Corridor 130-274/130-274(E)

San Juan/San Miguel Corridor

Corridor Review Table

Figure 4. Map of Conflict Areas in Vicinity of Corridor 130-274/130-274(E) (MP 0 to MP 8)

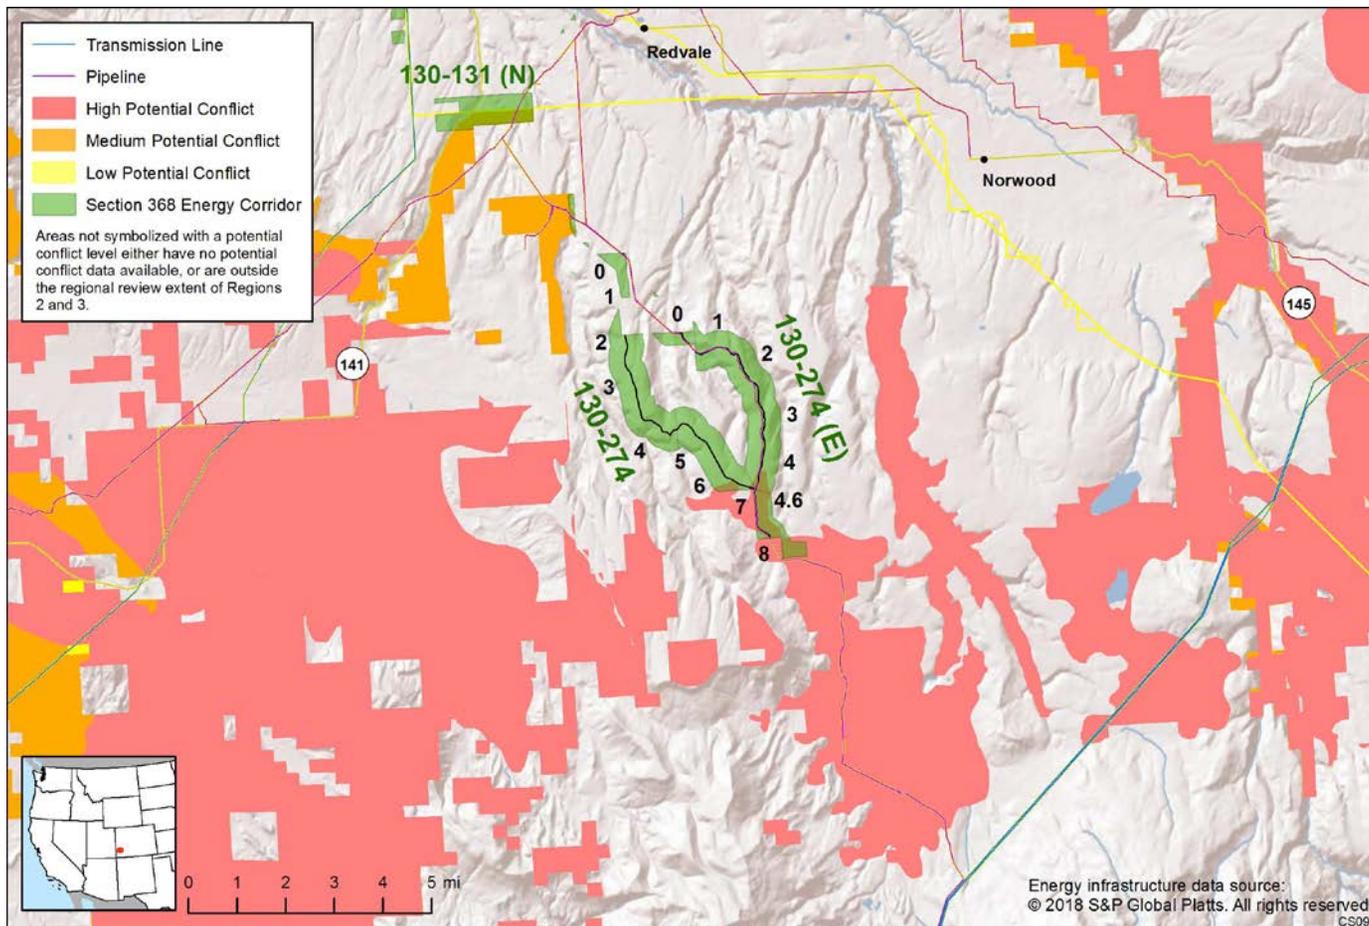
Figures 4 and 5 reflect a comprehensive resource conflict assessment developed to enable the Agencies and stakeholders to visualize a corridor's proximity to environmentally sensitive areas and to evaluate options for routes with lower potential conflict. The potential conflict assessment (low, medium, high) shown in the figure is based on [criteria](#) found on the WWEC Information Center at www.corridoreis.anl.gov. To meet the intent of the Energy Policy Act and the Settlement Agreement siting principles, corridors may be located in areas where there is potentially high resource conflict; however, where feasible, opportunity for corridor revisions should be identified in areas with potentially lower conflict.

Figure 6. Corridor 130-274/130-274(E), Corridor Density Map

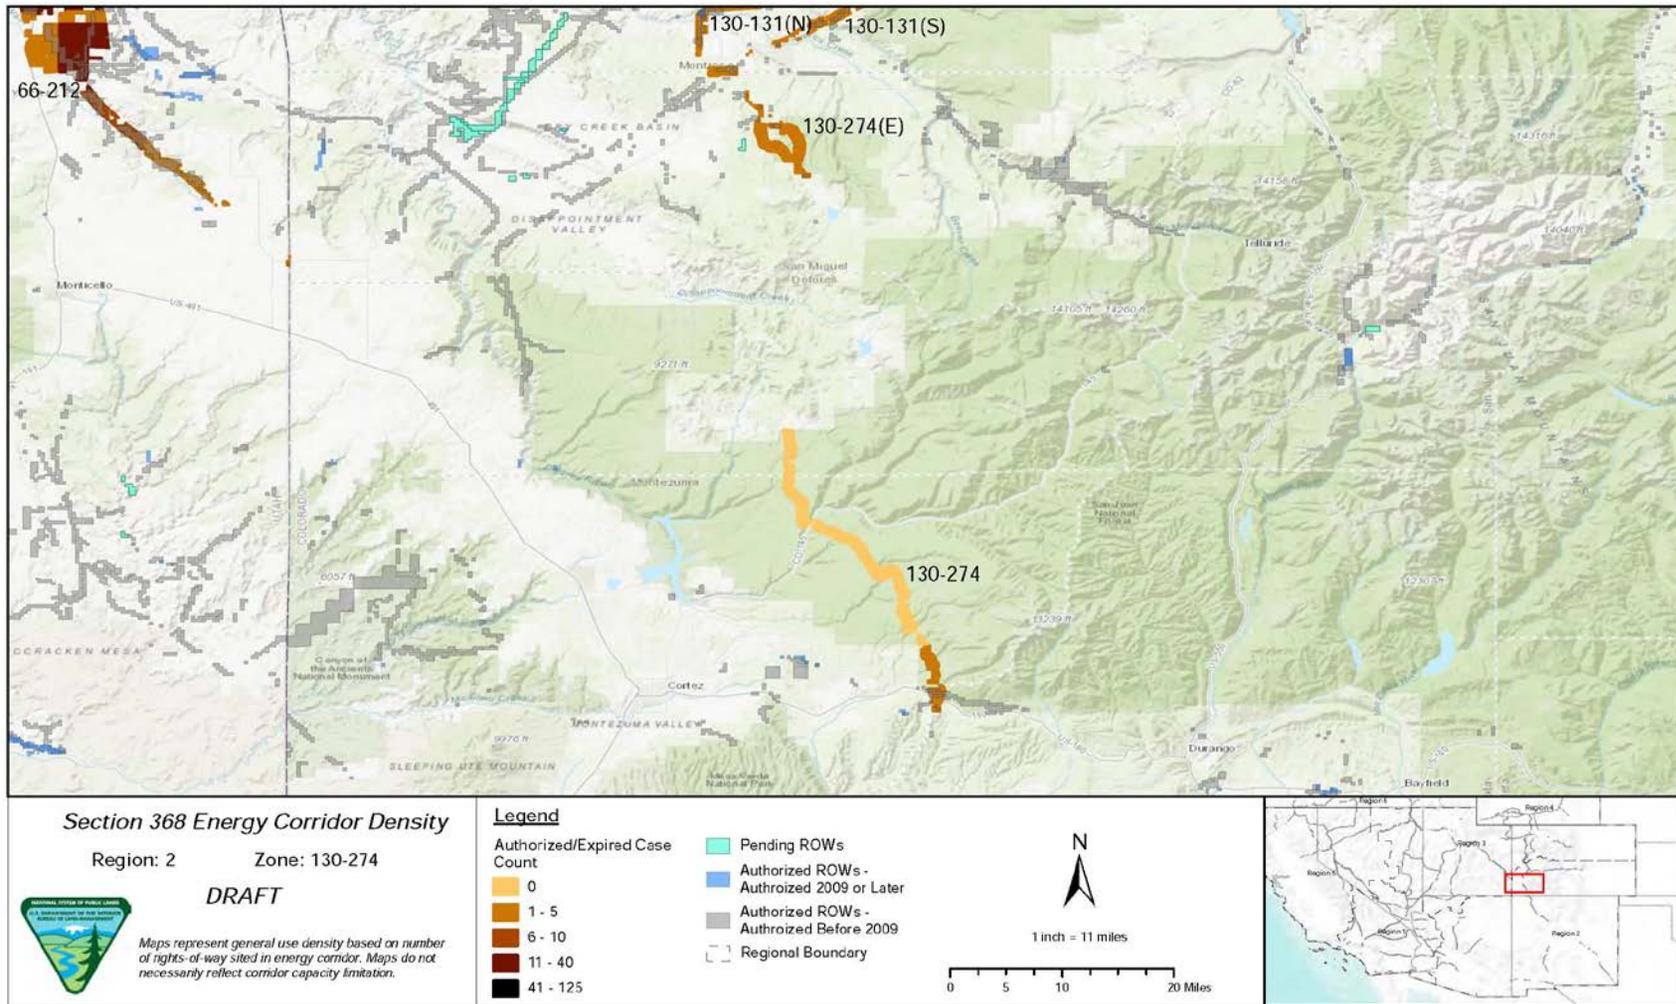
Figure 6 shows the density of energy use to assist in evaluating corridor utility. ROWs granted prior to the corridor designation (2009) are shown in grey; ROWs granted after corridor designation are shown in blue; and pending ROWs under current review for approval are shown in turquoise. Note the ROW density shown for the corridor is only a snapshot that does not fully illustrate remaining corridor capacity. Not all ROWs have GIS data at the time this abstract was developed. BLM and USFS are currently improving their ROW GIS databases and anticipate more complete data in the near future.
